Product Change Notification - SYST-03XNIB815

ERRATA - PIC32MZ Graphics (DA) Family Silicon Errata

PIC32MZ Graphics (DA) Family Silicon Errata and Data Sheet Clarification

FIGURE 1: Posc CRYSTAL CIRCUIT

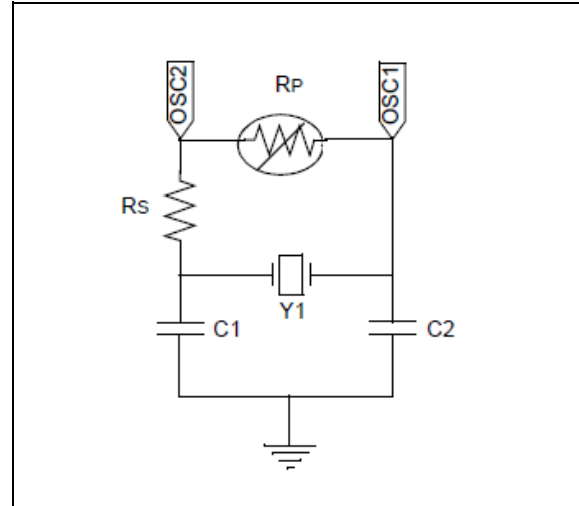
The POSC has been tested in a normal power-up sequence and supports specific crystal operation.

The Primary Oscillator (POsc) has been characterized to operate at 8 MHz and 12 MHz when the circuit shown in Figure 1 is implemented, and the operating conditions listed in Table 3 are met.

Alternatively, use an external clock or Internal FRC Oscillator. Note that communication interfaces (DDR2, USB, etc.,) with tighter clock accuracy requirements will not function with the FRC as clock source.

FIGURE 2: EXTERNAL RESET CIRCUIT

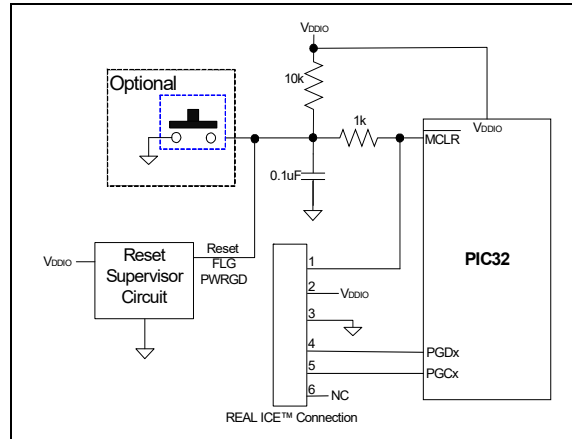
A system Reset is not generated on a BOR event ($V_{PORIO} < V_{DDIO} < V_{BORIO}$). This will stop system clocks with all the I/O pin functions frozen in the present state until either V_{DDIO} falls to V_{PORIO} or $V_{DDIO} > V_{BORIO}$.

Reset device using a \overline{MCLR} pin through an external reset supervisor/monitor is shown in Figure 2. Set the SMCLR (DEVCFG2<15>) configuration bit to '0', which makes the \overline{MCLR} to act as a POR Reset instead of a normal system reset.

- Minimum Reset trip voltage of the external supervisor should be $V_{BORIO} (Max)+0.5V$.
- The external reset supervisor/LDO output going to \overline{MCLR} should have an open drain output to not interfere with the MPLAB programming/debug tools.
